**METROPOLITAN GOVERNMENT OF NASHVILLE AND DAVIDSON COUNTY**

**STAFF RECOMMENDATION**  
**3610 Richland Avenue**  
**Lot 17, Richland Hall Development**  
**September 20, 2017**

**Application:** New construction—infill and outbuilding  
**District:** Richland-West End Neighborhood Conservation Zoning Overlay  
**Council District:** 24  
**Map and Parcel Number:** 10409029200  
**Applicant:** Chad Gore, Mike Ford Builders  
**Project Lead:** Melissa Baldock, melissa.baldock@nashville.gov

**C2**

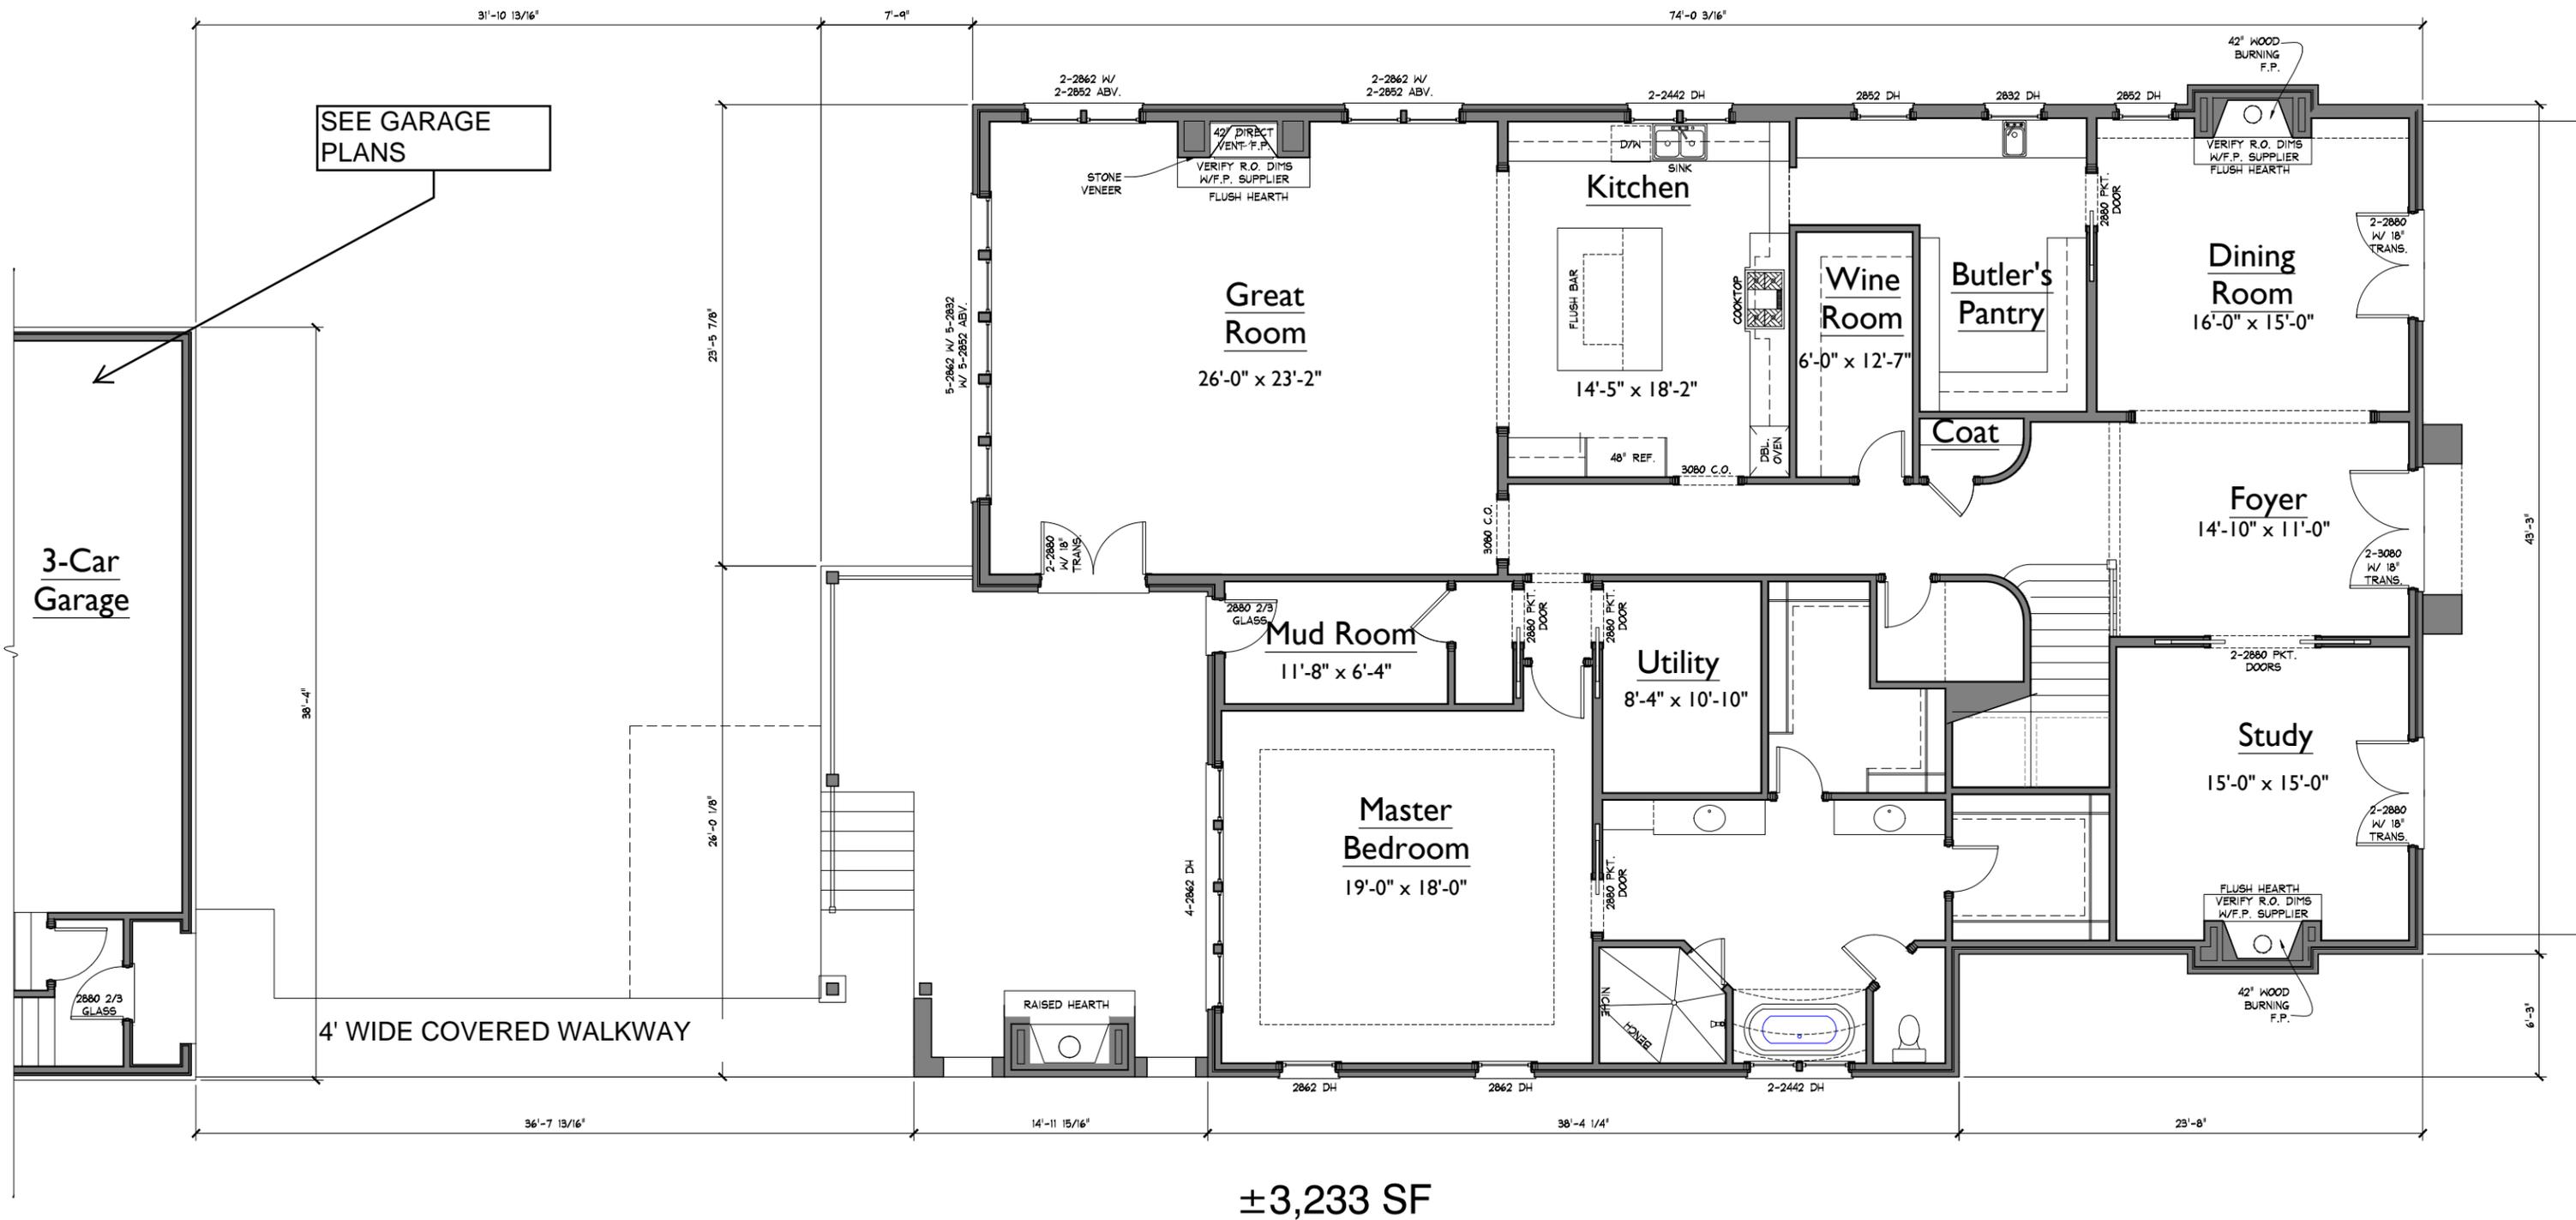
Setback & Rhythm of Spacing: The proposed infill will meet all base zoning setbacks. The front setback for this development is proposed to be fifty feet (50’), in order to line up with the historic house at 3618 Richland Avenue. Staff recommends that MHZC staff approve the staking of the front setback in the field to ensure that the fifty feet (50’) setback does line up with the front wall of 3618 Richland Avenue.

The infill will be six feet, two inches (6’2”) from the left side property line and will be five feet, eleven and a half inches (5’ 11½”) from the right side property line. It will be over sixty feet (60’) from the rear property line. Staff finds that the proposed setbacks to be similar to the immediate historic context and to meet Section II.B.1.c. of the design guidelines.

Appurtenances & Utilities: The driveway at the rear will be concrete, as will the walkway leading to the front porch from the sidewalk. No fencing was indicated on the site plan. The HVAC unit will be located on the left side elevation, about thirty feet-three (33’) back from the front of the house. Staff finds that the infill meets Section II.B.1.i. of the design guidelines.

1. The finished floor height be consistent with the finished floor heights of neighboring historic houses, to be verified by MHZC staff in the field;
2. The front setback be verified in the field;
3. Staff approve the stone sample prior to purchase and installation;
4. Staff approve color and texture of the asphalt shingle and metal roof;
5. Staff approve the materials for the porch floors and stairs;
6. Staff approve all window and door selections prior to purchase and installation;
7. Staff approve the foundation material for the outbuilding.

**1 FRONT ELEVATION**  
1/8" = 1'-0"

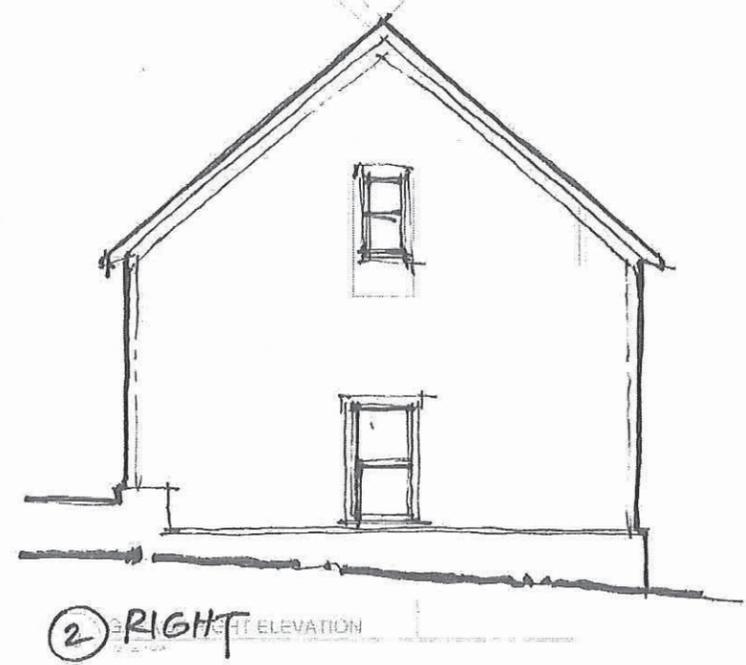
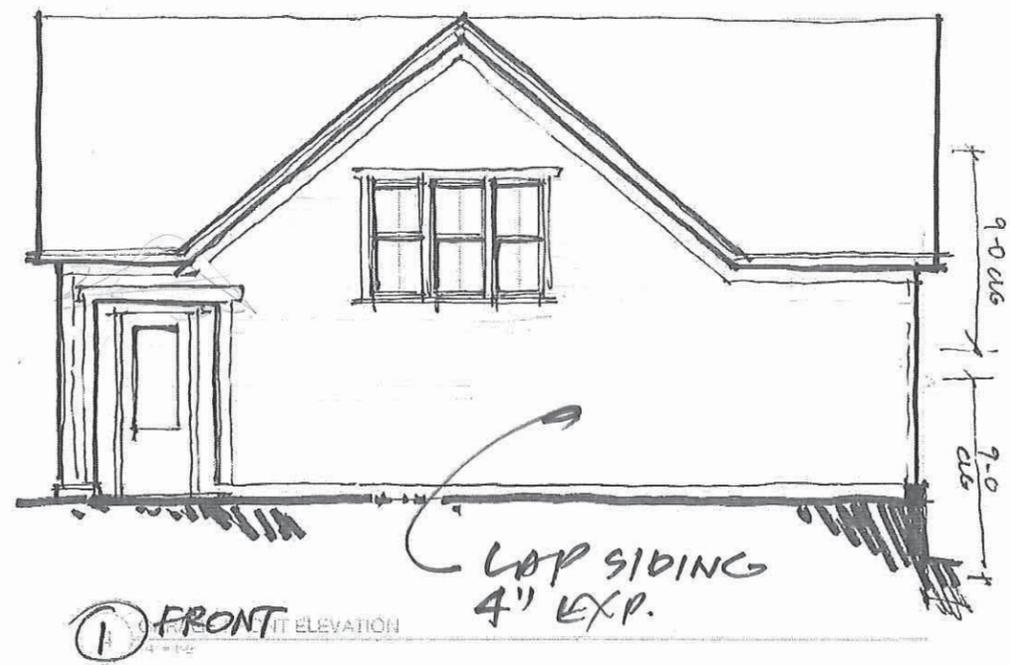
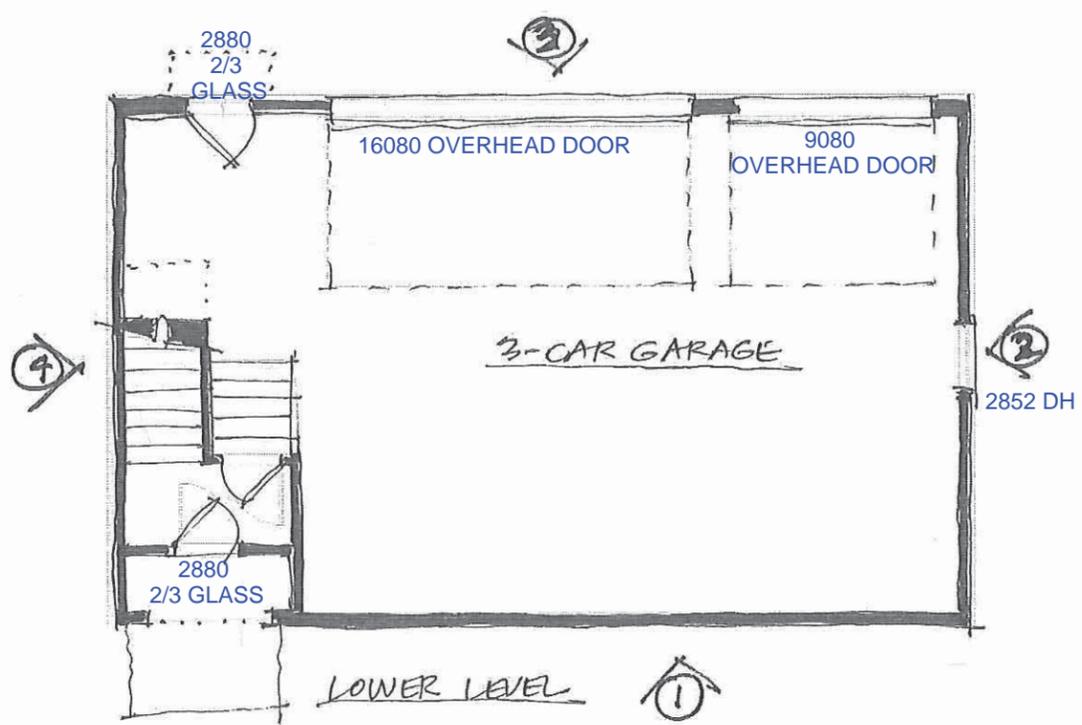
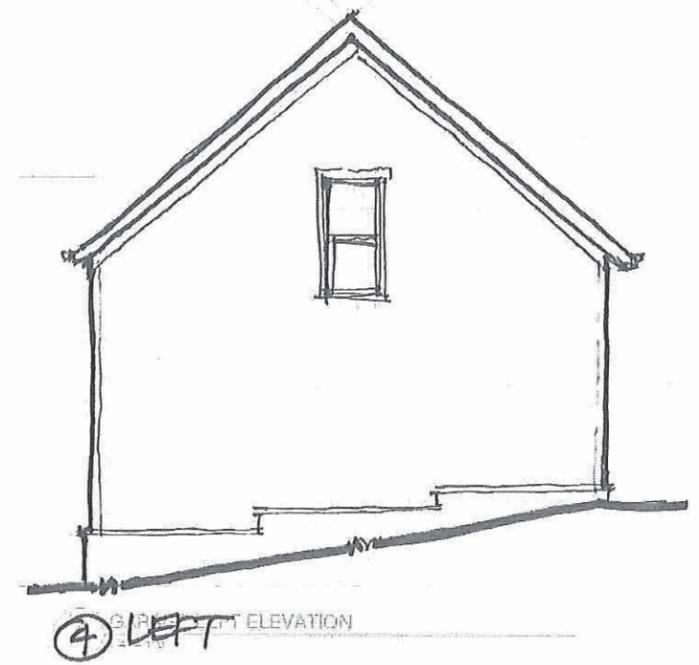
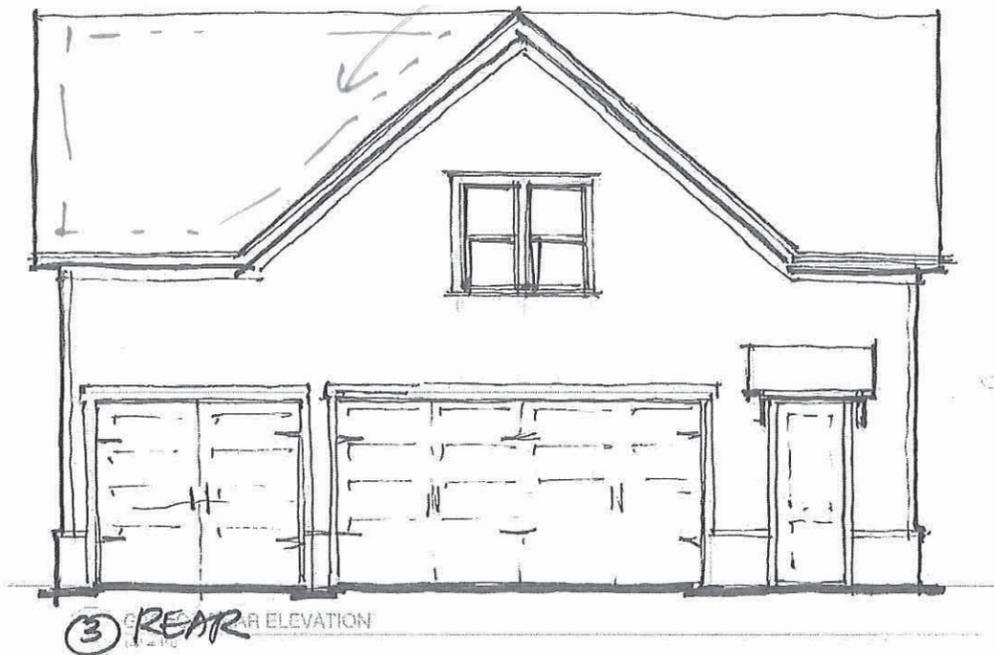
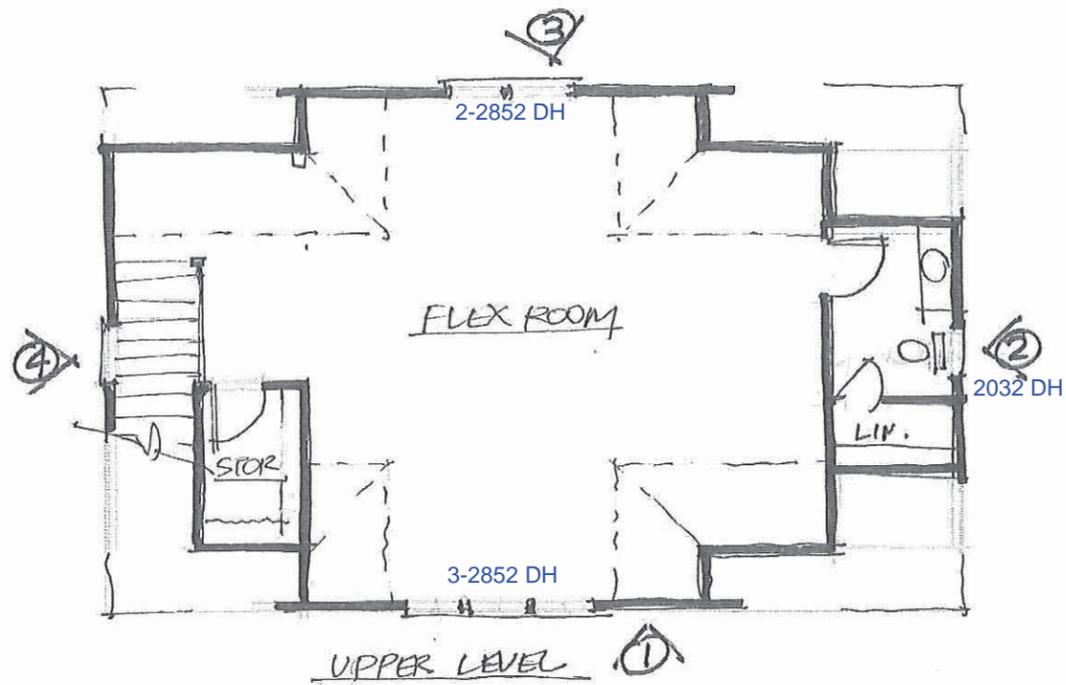
**Height & Scale:** The proposed infill will be two stories, with a maximum height of thirty-three feet, six inches (33'6") above the foundation at the front, and approximately thirty-five feet (35') above grade. The infill will have an eave height of twenty feet (20') above the grade at the front. The foundation height will vary due to grade, but will be between twelve and eighteen inches (12"-18") at the front. Staff finds that the proposed height is similar to the heights of historic houses in the immediate vicinity, which range from thirty to forty-four feet (30' – 44'). It is also in keeping with what has been approved in the past for the infill houses in this development.

Roof form: The infill's primary roof form is a hipped roof with a 11.5/12 pitch. A projecting bay on the side will also have a hipped roof form with a 11.5/12 pitch. The applicant is proposing wall dormers on the front and the side. The design guidelines discourage wall dormers on the front, primarily because they are not typical of many neighborhoods and they increase the perceived height of the house. Staff, however, finds the proposed wall dormers to be appropriate for several reasons.

Proportion and Rhythm of Openings: The proposed windows on the infill are generally twice as tall as they are wide, thereby meeting the historic proportion of window openings. There are no large expanses of wall space without a window or door opening. All double and triple window openings have a four to six inch (4”-6”) mullion in between them. On the right elevations, there are some double-height window openings that are not typical of the historic context. Staff finds them to be appropriate, however, because they are over fifty-feet (50’) back from the front of the house. Staff finds that the infill’s proportion and rhythm of openings meet Section II.B.1.g. of the design guidelines.
